North Carolina Building Code Council

RE: Agenda for the July 14, 2020 NC Building Code Council Meeting

1. The NC Building Code Council Meeting will begin at 9:00AM on Tuesday, July 14, 2020 (Albemarle Building).
2. Standing Committees will meet in the afternoon on Monday, July 13. Schedule to be set by Chairman.
3. The Agenda is printed as follows:
 - A-Items- Administrative items that require Council action but are not subject to Rule-Making.
 - B-Items- New amendment petitions introduced at this meeting.
 - C-Items- Amendments that have been granted by the Council and advertised in the NC Register for public hearing.
 - D-Items- Adoption of amendments by the Council prior to approval by the Rules Review Commission.
 - E-Items- Reports from Committees and Staff.
 - F-Items- Notice of Appeal Hearings.

**FIGURE R4603.6(d2)
CORNER PILE CONNECTION**

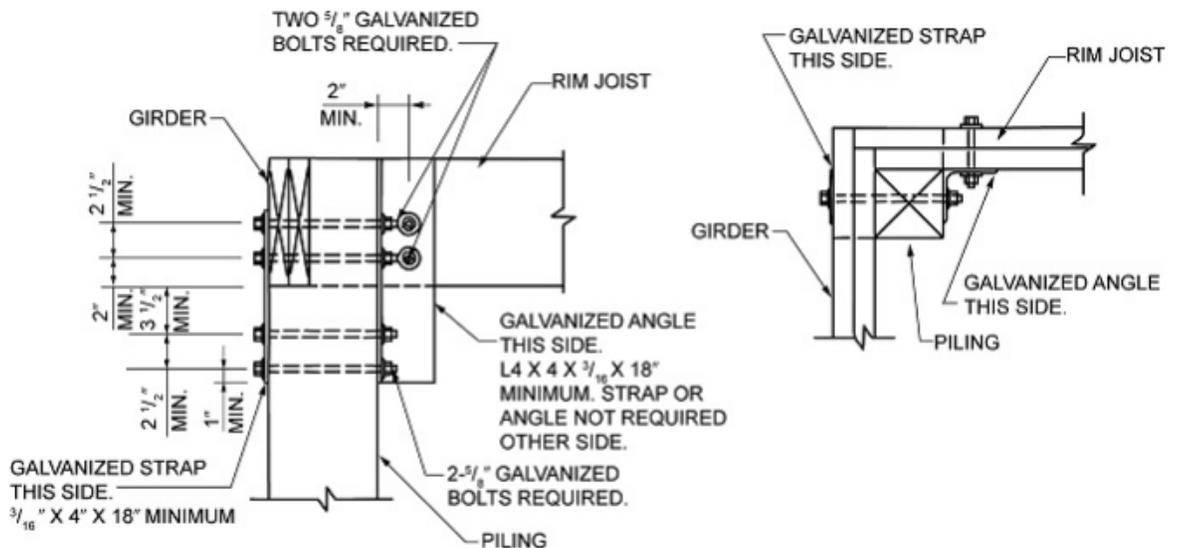
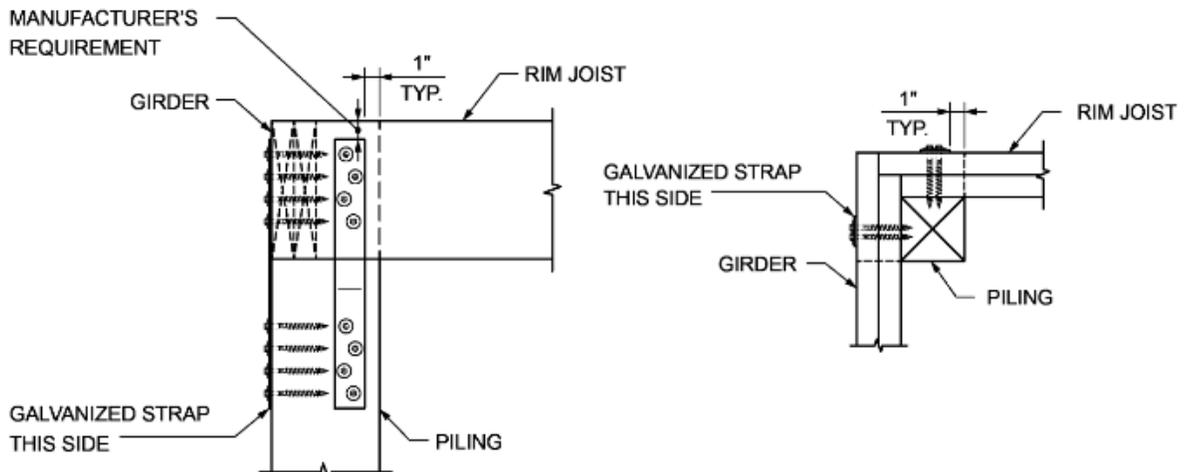
Item B – 21 Request from Jackie Flemming and Doug Allen P.E. representing Simpson Strong-Tie to amend the 2018 Residential Building Code, Section R4603.6.1 as follows:

R4603.6.1 Tying at corners. At corners, girders shall be connected to the pile with a minimum 3/16 × 4 × 18-inch (5 × 102 × 467 mm) hot dip galvanized strap bolted with two 5/8 inch (15.9 mm) galvanized through bolts on the exterior and a minimum L4 x 3/16 x 1'-6" (102 × 5 × 467 mm) galvanized steel angle bolted with two 5/8 inch (15.9 mm) galvanized through bolts on the interior in accordance with Figure R4603.6(d1), or with a minimum of (2) 3/16" x 4" x 18" (5x102x467 mm) hot dip galvanized straps installed on the outside of the girders with fasteners per table R4603.6.1 and in accordance with Figure R4603.6 (d2).

Table R4603.6.1 Minimum Fastening of Corner Beams and Girder to Pilings

<u>Amount Piling is Notched</u>	<u>Associated Figure</u>	<u>Hardware</u>	<u>Fasteners</u>
<u>> 50%¹</u>	<u>R4603.6(d)</u>	<u>one 3/16"x4"x18"</u>	<u>six 5/8" bolts²</u>
		<u>one L4x3/16x18"</u>	
	<u>R4603.6 (e)</u>	<u>one 3/16"x4"x18"</u>	<u>eight 0.27"x4" each³</u>

FIGURE AM105.2
TYPICAL DECK GIRDER SPANS

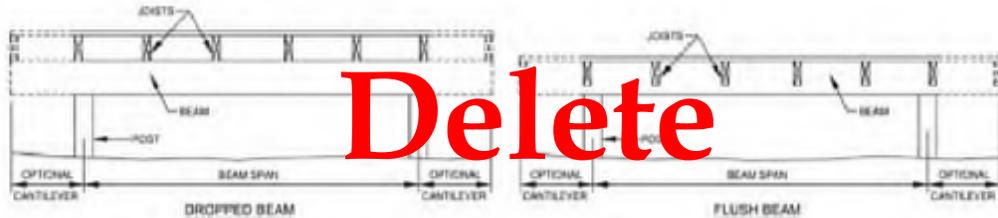
~~**AM105.2 Girder span for uncovered porches and decks.** Maximum allowable spans for wood deck girders, as shown in Figure AM105.2, shall be in accordance with Table AM105.2. Girder plies shall be fastened with two rows of 10d (3-inch x 0.128-inch) nails minimum at 16 inches (406 mm) on center along each edge. Girders shall be permitted to cantilever at each end up to one fourth of the actual beam span. Splices of multispan beams shall be located at interior post locations.~~
